Agenda Item # 10

SUB-003723-2026

The Residences at Oakleigh Subdivision, Phase Two

- Subdivision approval to create four (4) legal lots of record from one (1) existing metes-and-bounds parcel.

DETAIL SITE PLAN

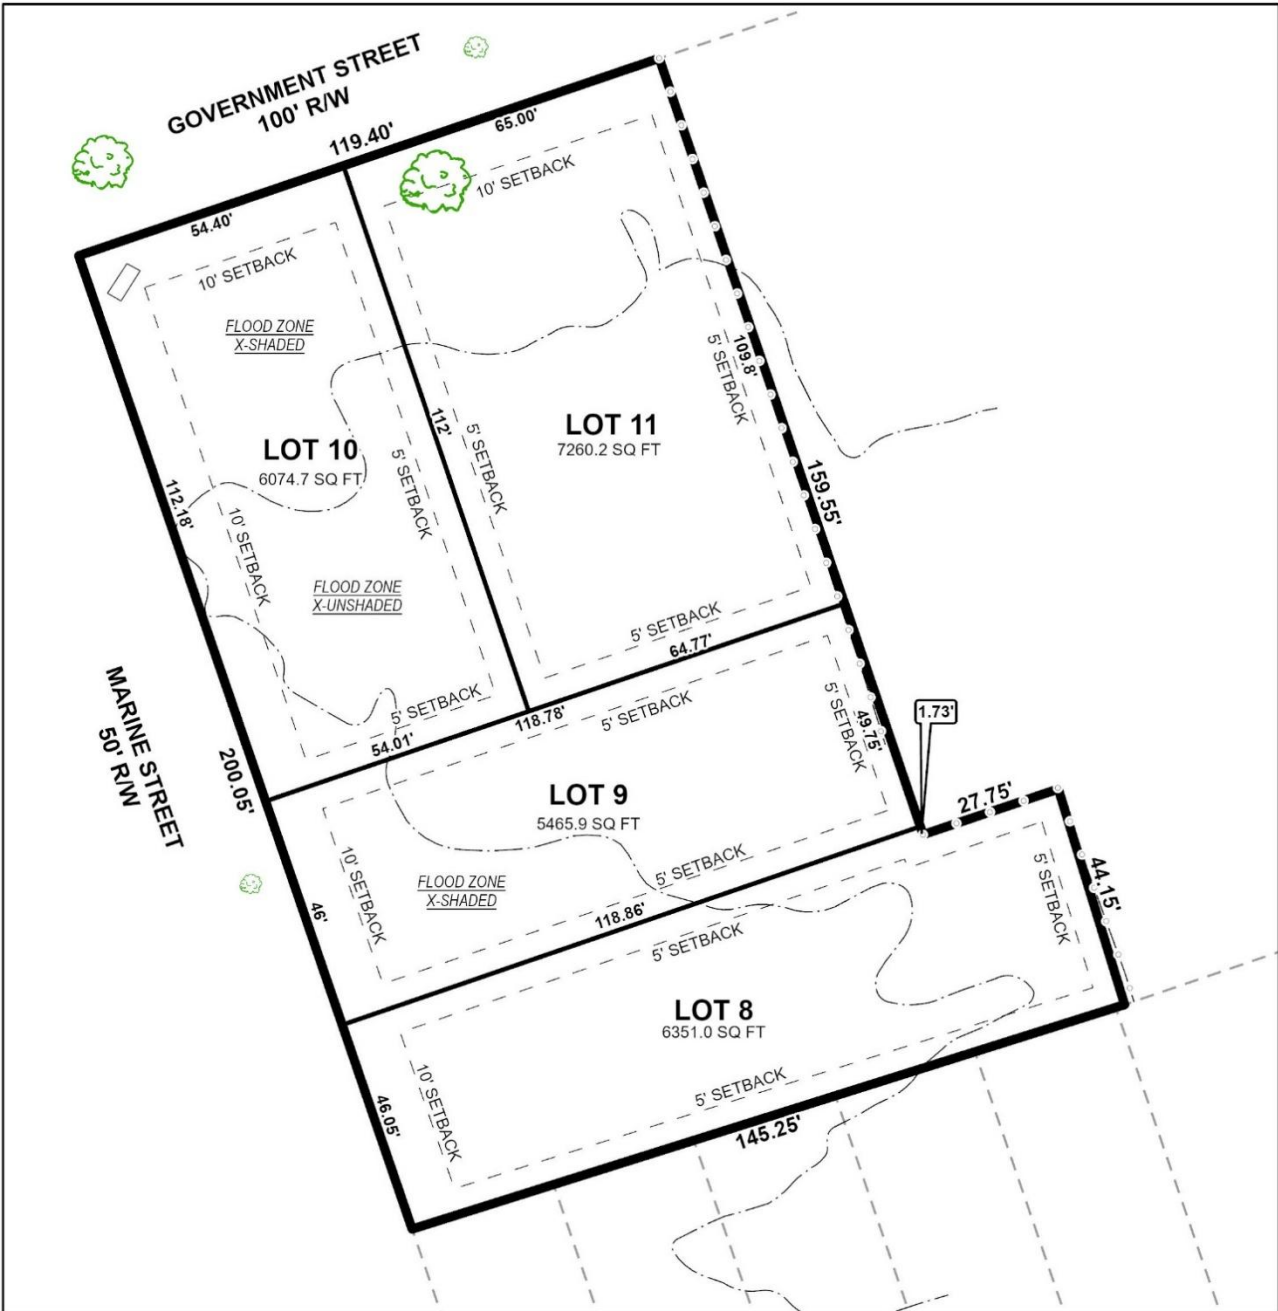
Proposed Lot 10 is a corner lot requiring at least a 25-foot corner radius at the intersection of Government Street and Marine Street, per Section 6.C.6. of the Subdivision Regulations. As such, the plat should be revised to illustrate at least a 25-foot corner radius at the intersection of Government Street and Marine Street. If a reduced corner radius is approved, approval from the City Engineer and a waiver of Section 6.C.6. will be required.

A 10-foot front yard setback is depicted along both Government Street and Marine Street on the preliminary plat. However, the site is located within the Oakleigh Garden Historic District Overlay (HDO), where front yard setbacks are required to be consistent with those of structures located on the same side of the street within 150 feet of the proposed building site, measured in both directions and exclusive of the right-of-way.

Because front yard setbacks within the HDO are determined by the context of surrounding development, the 10-foot front yard setback should be removed from the plat. If approved, a note should be placed on the Final Plat stating that development of the site shall comply with the provisions of Article 14 of the UDC, including the front yard dimensional standards applicable within the Historic District Overlay.

The preliminary plat also depicts 5-foot side yard and rear yard setbacks on all proposed lots. These setbacks should likewise be removed from the Final Plat, if approved.

Section 6.C.2.(b)(3) of the Subdivision Regulations states that residential lots located within an area designated as Urban in the Unified Development Code shall be a minimum of 50 feet wide at the building setback line. Proposed Lots 8 and 9 are 46.05 feet and 46.00 feet wide at the building setback line, respectively. Therefore, if approved, a waiver of Section 6.C.2.(b)(3) will be required.

3. Revision of the plat to provide a minimum 25-foot corner radius at the intersection of Government Street and Marine Street, in compliance with Section 6.C.6. of the Subdivision Regulations, unless the City Engineer approves a smaller radius and the Planning Commission grants a waiver of Section 6.C.6.;

4. Revision of the plat to remove the 10-foot front yard setback line along Government Street and Marine Street;
5. Revision of the plat to remove the side and rear setback lines on all lots;

6. Placement of a note on the Final Plat stating that all development on the site shall comply with the provisions of the Historic District Overlay (HDO) in Article 14 of the UDC, including the applicable front yard setback requirements;
